AP - 75

# STAGE 1 & 2 WORKPLANS

**From:** Laura Pena <lpena@riceswd.com>  
**Sent:** Thursday, May 03, 2012 10:07 AM  
**To:** Hansen, Edward J., EMNRD  
**Cc:** Hack Conder; Katie Jones; L Peter Galusky Jr  
**Subject:** BD J-26 (AP-75) Project Update Addendum  
**Attachments:** BD J-26 - Proposed MW-4.jpg

The following is an Addendum to the BD J-26 (AP-75) Project Update report submitted to the NMOCD on April 17, 2012.

# Site map

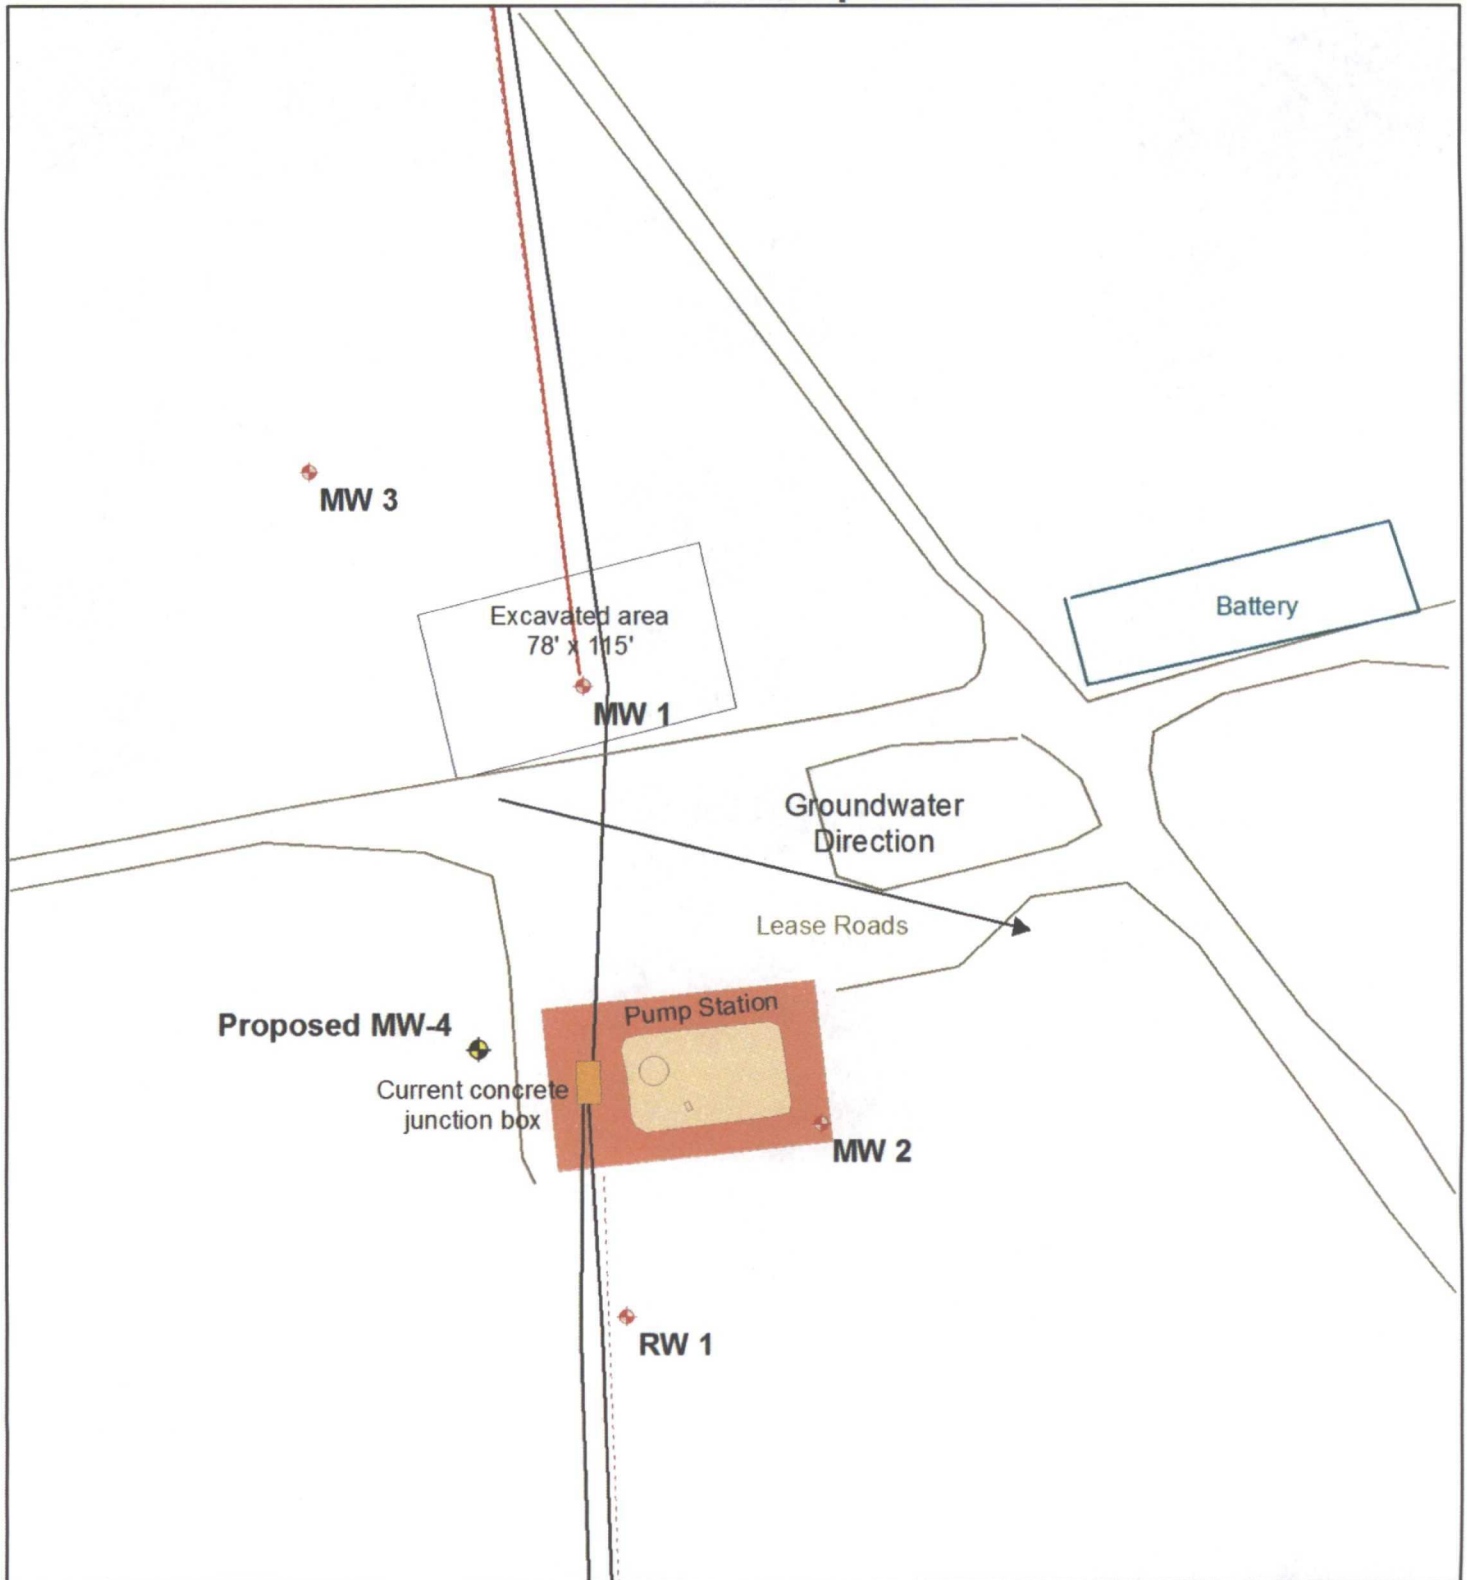
Page 2, paragraph 3: *Proposed Path Forward*; red lettering will be deleted from the paragraph and blue lettering will be added to the paragraph.

"We believe, based on the analyses and results presented here, that the BD J-26 site is no longer a threat to groundwater quality. We therefore propose to ~~cease further sampling from monitor wells MW-1, MW-3 and RW-1 and to plug and abandon these wells~~ install one two inch monitor well upgradient of MW-2 (west) per NMOCD request during the May 1, 2012 meeting between ROC and NMOCD. ~~However,~~ We propose to continue ~~to~~ sampling ~~MW-2~~ on a quarterly basis ~~through 2012~~ and to submit a report to NMOCD with recommendations ~~when ROC has further delineated upgradient water conditions for the best path forward by April 1, 2013.~~ See attached plat for approximate location."
